Lime Down

Solar Park

Change Notification

Document Reference: EXAM/9.35

Change Application - Change 1 (Subject to change)

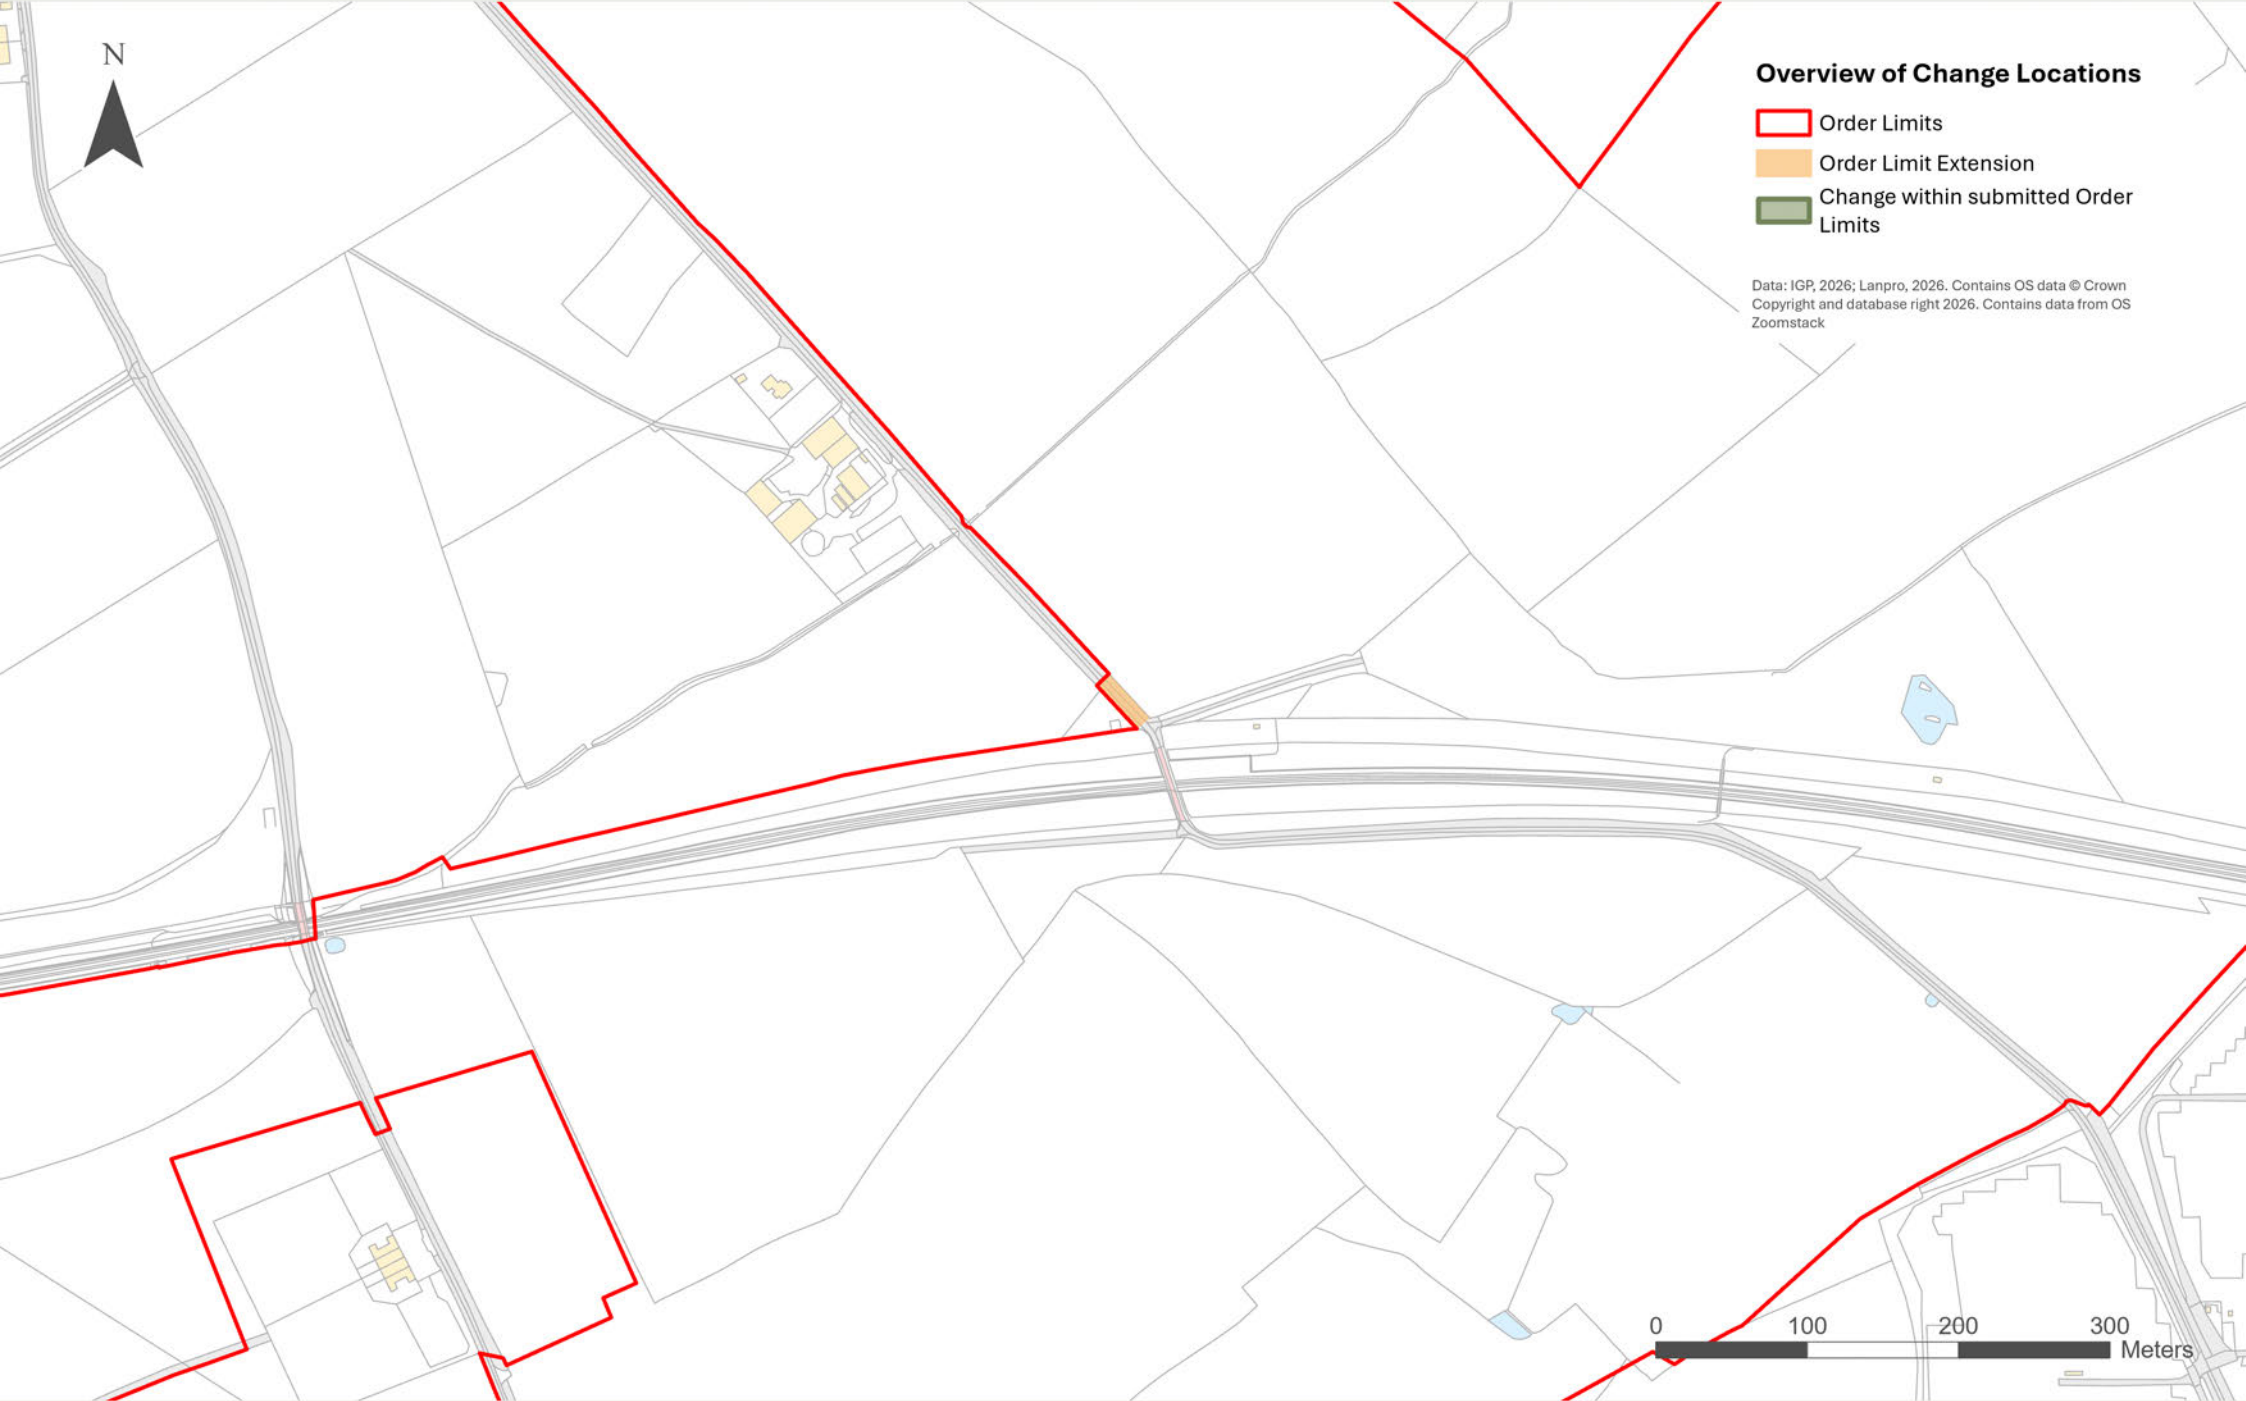
2.1.1 Change 1 comprises an extension to the Order Limits from the south western extent of the BESS emergency access (Access 21) at Lime Down D to the public highway named Hills Hayes Lane. A post-submission review by the Applicant of the Scheme accesses indicated that Access 21 did not adjoin the boundary of the public highway. This change will allow emergency Access 21 to tie into the public highway. The additional land will contain the bellmouth of emergency Access 21 which will comprise hardcore or gravel over a levelling layer of substrate.

2.1.2 The area of the land to be added to the Order Limits is approximately 0.044ha.

Change Application - Change 2

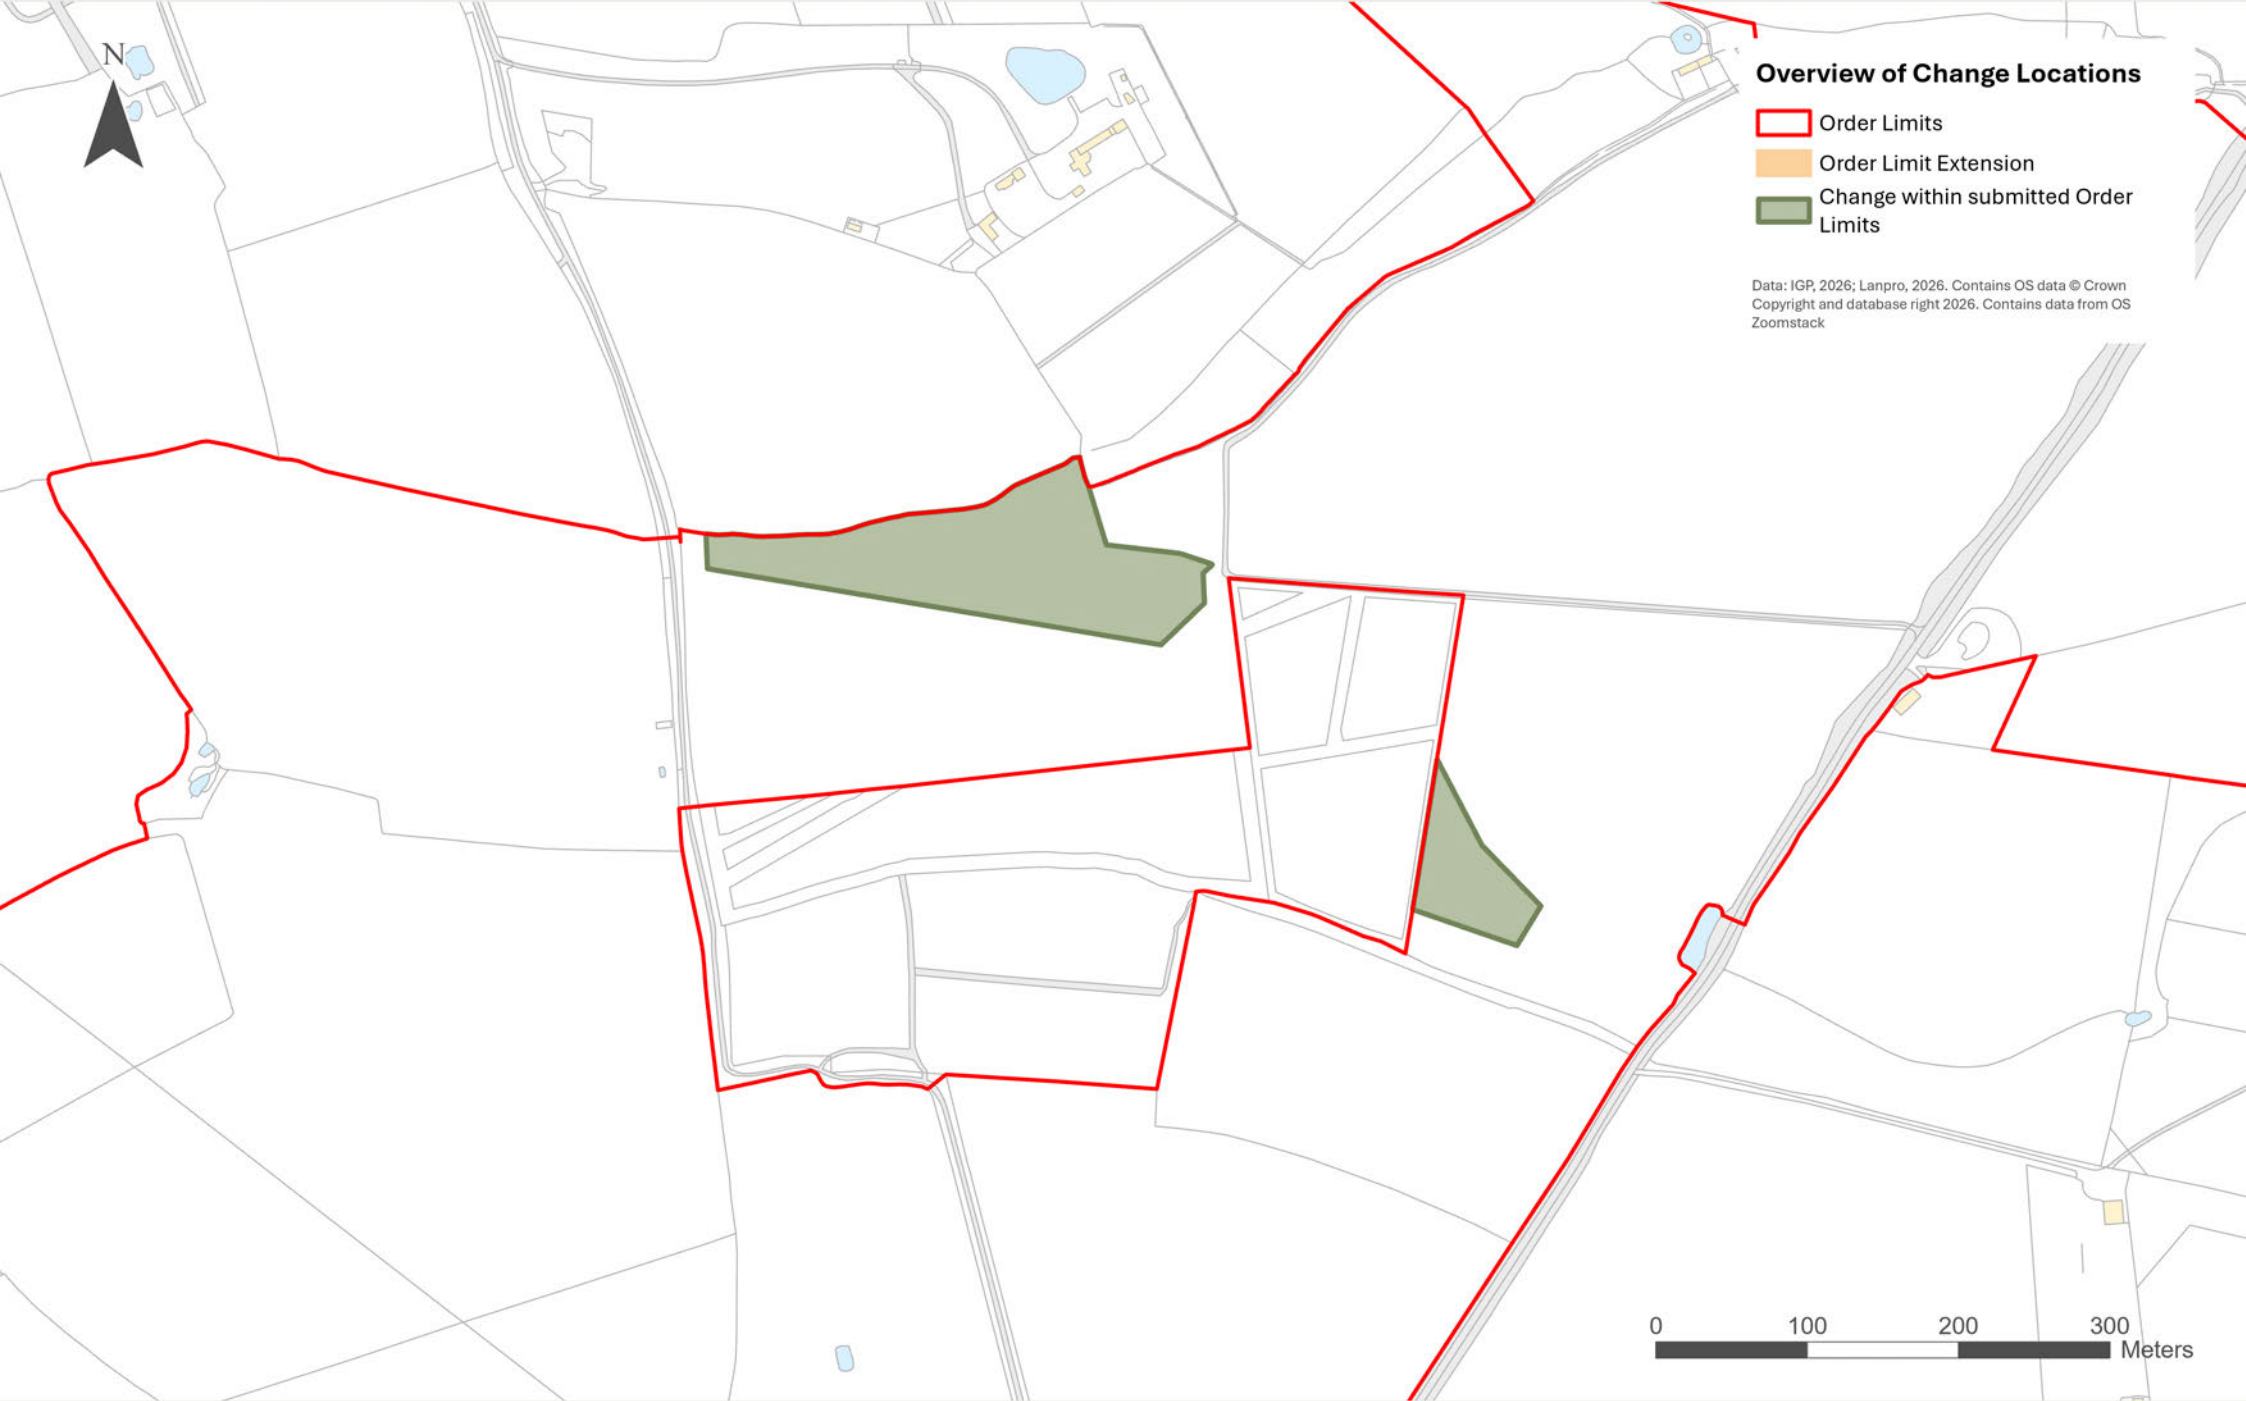
2.2.1 Change 2 comprises an update to the Works Plan to reflect the realignment of Solar PV Infrastructure within parts of Fields C21 and C23. This change reflects updated GIS data provided by Wiltshire Council that confirms the alignment of PRoW WT/SHER/18 as per the definitive map dated 5 March 2026, which has changed since the DCO Application was submitted.

2.2.2 There will be no change to the extent of Work Number 1, and the realigned Solar PV Infrastructure will retain a 15m offset from the PRoW.

Change Application - Change 3.1

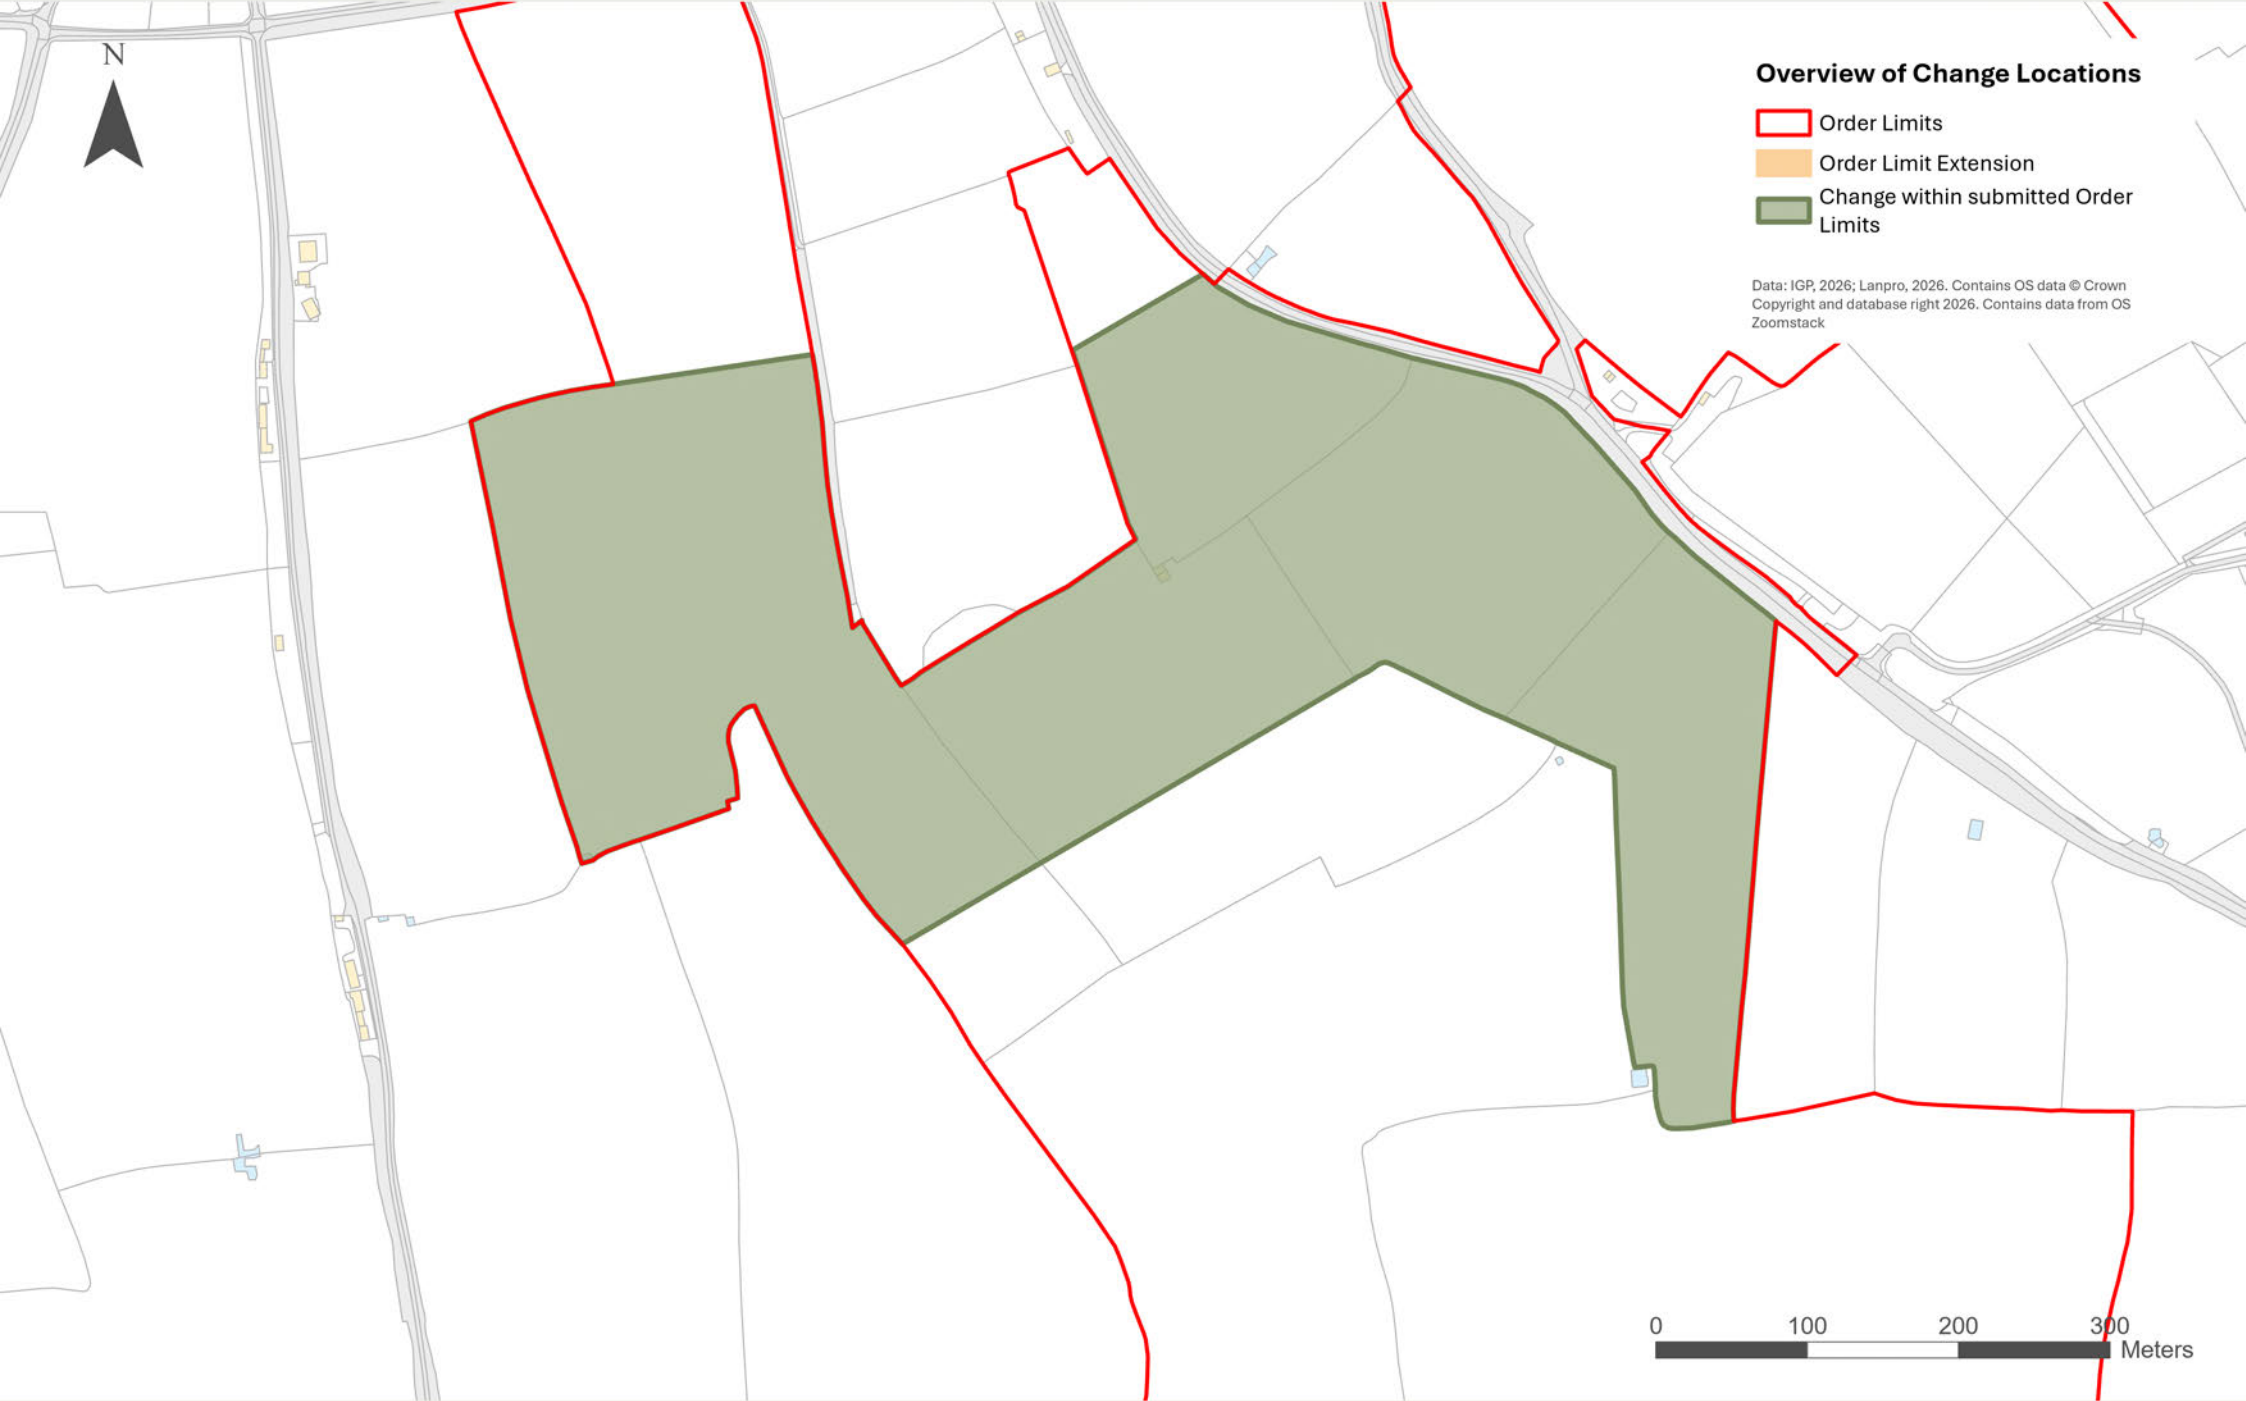
2.3.1 Change 3 comprises an update to some areas within Lime Down A, C and E to include Work Number 5B (electrical cables up to 132 kV (referred to as interconnecting cables in Table 3-1 in **ES Volume 1, Chapter 3: The**

Scheme [APP-055]) in addition to Work Number 1(d) (electrical and communications cabling (referred to as on-site cables in Table 3-1 in **ES Volume 1, Chapter 3: The Scheme [APP-055])**).

- 2.3.2 The area comprising Work Number 1(d) allows for electrical and communications cabling within the Solar PV Sites, and some areas of Work Number 1(d) already include areas of Work Number 5B, however incorporating Work Number 5B across the entire area of Work Number 1(d) allows for more flexibility at the detailed design stage in the routing of the interconnecting cables between the Conversion Units, 33 kV Sub-distribution Switch Rooms, 132 kV Substations, 400 kV Substation and the Solar PV Sites. The plan provided shows the additional area in Lime Down A (Change 3.1), Lime Down C (Change 3.2) and Lime Down E (Change 3.3) where the Applicant is seeking to include Work Number 5B in addition to Work Number 1(d).

- 2.3.3 All cabling will be underground, and subject to the parameters stated in the Design Principles and Parameters document **[EN010168/APP/7.4]** (Revision 3). There is no change to the extent of the Order Limits associated with Work Number 5B being included in addition to Work Number 1(d). Change 3 allows for the interconnecting cables to be laid in the same location as on-site cables, where possible, including the design flexibility to place both interconnecting cables and on-site cables into a single trench.
